UNITED STATES PATENT AND TRADEMARK OFFICE

Office Action Summary

10/501,109

DETAILED ACTION

FIG. 2

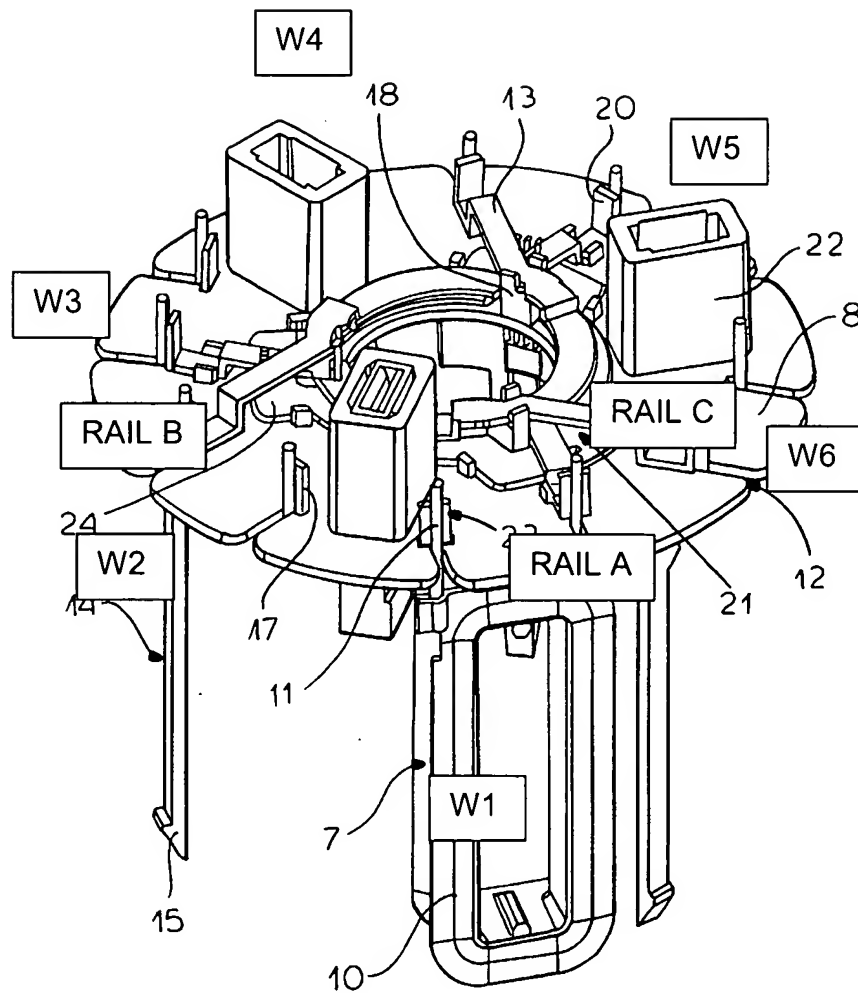
Regarding claim 1, Lutkenhaus et al. shows a stator assembly (3) having a plurality of stator poles (located in bobbin 10), said plurality being divisible by six (column 3, line 5),

- A first, a second, a third, a fourth, a fifth and a sixth of said stator poles being arranged successively within a predetermined angular range (Figure 2);
- Three winding phases (shown coil 7 in Figure 2 and its across coil forming first phase) connected in a delta (column 2, line 34) configuration;
- Three respective current rails (13) associated with respective ones of said winding phases for their connection; wherein

- A first winding coil (W1) is arranged on said first stator pole (in bobbin 10) between a first one (RAIL A) of said current rails and a second one (RAIL B) of said current rails;

- A second winding coil (W2) is arranged on said second stator pole between said second current rail (RAIL B) of said current rails and a third one (RAIL C) of said current rails (relative position of W2 is between RAIL B at left side and RAIL C at right side);

- A third winding coil (W3) is arranged on said third stator pole between said third current rail (RAIL C) and said first current rail (RAIL A);
- A fourth winding coil (W4) is arranged on said fourth stator pole between said first current rail (RAIL A) and said second current rail (RAIL B);

- A fifth winding coil (W5) is arranged on said fifth stator pole between said second current rail (RAIL B) and said third current rail (RAIL C) and
- A sixth winding coil (W6) is arranged on said sixth stator pole between said third current rail (RAIL C) and said first current rail (RAIL A).

Regarding claim 4, it is noted that Lutkenhaus et al. also shows at least one of said current rails (13) being configured to interconnect a plurality of interface points (the other end of RAIL A), said interface points being separated by three intervening stator poles (W1, W2, and W3).
